# 5335A UNIVERSAL FREQUENCY COUNTER

ADDENDUM TO:  
5335A OPERATING AND SERVICE MANUAL  
HP PART NUMBER: 05335-90021

CHANGES AND ENHANCEMENTS  
 TO  
 HP 5335A UNIVERSAL FREQUENCY COUNTERS  
 WITH  
 FIRMWARE REVISION 1.1

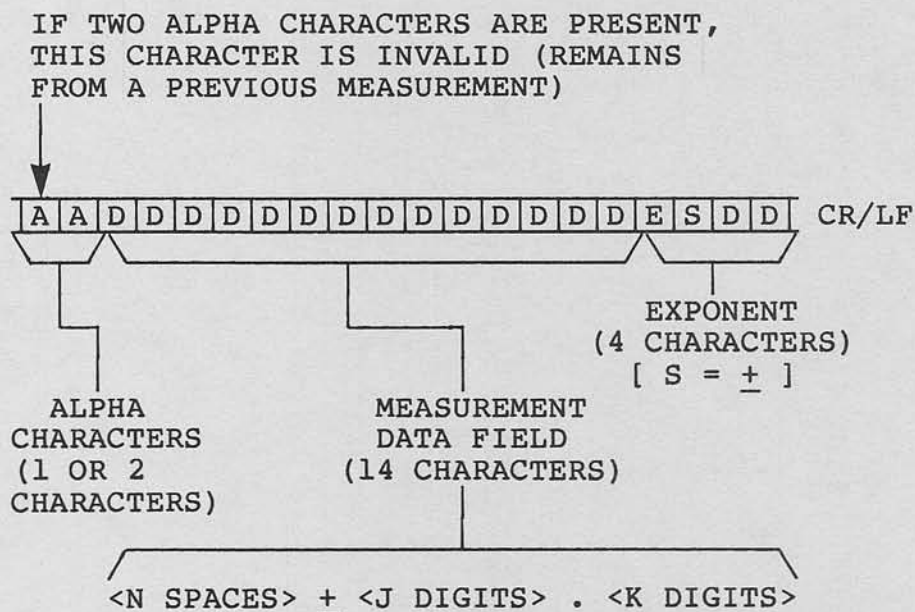
A        3-32    Paragraph 3-212. Replace the paragraph and diagram with the following:

3-212. After a measurement, the 5335A outputs the data to the HP-IB. The output byte will contain 19 or 20 characters, followed by a "CR" and "LF" (carriage return and line feed) as shown in the diagram below:

If firmware Revision 1.1 is installed, dimension output string variables one character longer than with firmware Revision 1.0 to allow for the double alpha output. Failure to do so may result in loss of data or controller error. Also note that the program examples on Pages 3-35 through 3-45 will need to be modified to work properly.
